# PCI 9056BA

Revision 1.5  
March 2006

## Errata Documentation

## 8. PME# Pin Isolation

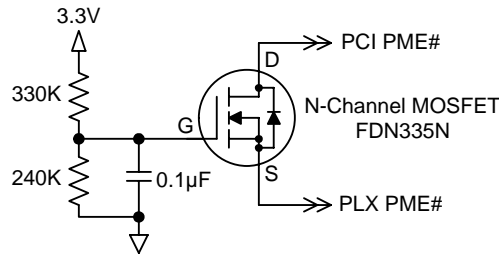
**Documented Behavior:** Components that support the PCI Power Management D3cold state and implement PME# must ensure that, whenever main power is removed, the non-powered PME# generating logic and its output do not present a low impedance path to ground. Otherwise, there could be an accidental system wake up event.

**Actual Behavior:** The silicon does not ensure such protection and does present a low impedance path to ground when in the D3cold state, essentially causing an accidental wake up event every time the add-in card is inserted.

If PME# is to be implemented, an external FET must be inserted between the silicon's PME# signal pin and the PCI Slot. Suggested circuit:
